July 5, 2018

Re: NOTICE OF EX PARTE
WT Docket No. 10-208: *Universal Service Reform –*
Mobility Fund
WC Docket No. 10-90: *Connect America Fund*

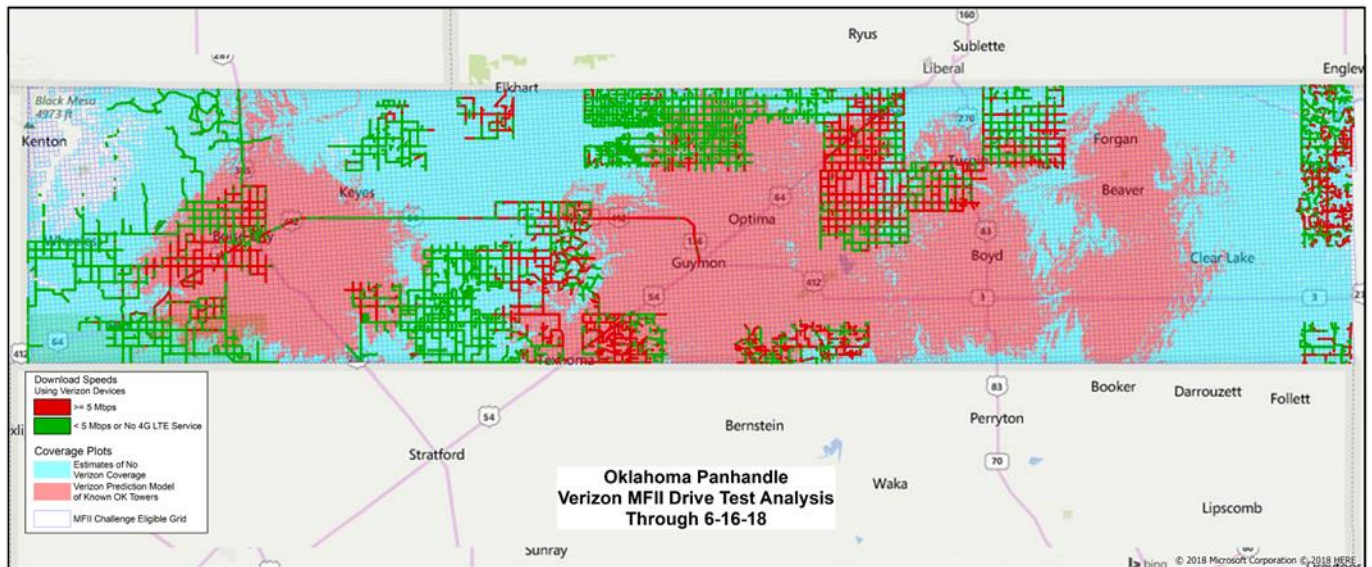
This map of the Oklahoma Panhandle indicates the testing completed by Panhandle as of June 16, 2018. The red areas indicate test points receiving 5 Mbps or higher and the green areas represent tests below 5 Mbps or those that did not register 4G LTE service. The pink is an estimate by MRL of service area for Verizon and the blue area indicates estimated area of less than 5 Mbps down load speed or no LTE coverage by Verizon. Verizon publicly claims to provide 4G LTE service throughout most of the depicted area.⁷

Panhandle's data collection depicted on the map above covered 4,911.84 miles (7,904.84 kilometers) and a total of 402,573 test points. Of the total test points collected, 357,374 (88.8%) tested below 5 Mbps download speed or did not register 4G LTE service at all on Verizon-designated handsets. MRL is aware that Panhandle has spent more than \$300,000 since the MF-II Challenge Process opened on employee wages, testing handset and data expenses, regulatory and engineering consulting fees, wear and tear on vehicles, and fuel for its testing vehicles, and Panhandle is estimated to spend an additional \$650,000 to complete the challenge process if the overstated coverage is not corrected. In addition to hard out of pocket expenses, Panhandle is losing out on opportunities to expand its LTE footprint and has delayed the planning process for 5G implementation due to staff being occupied with the Challenge Process.
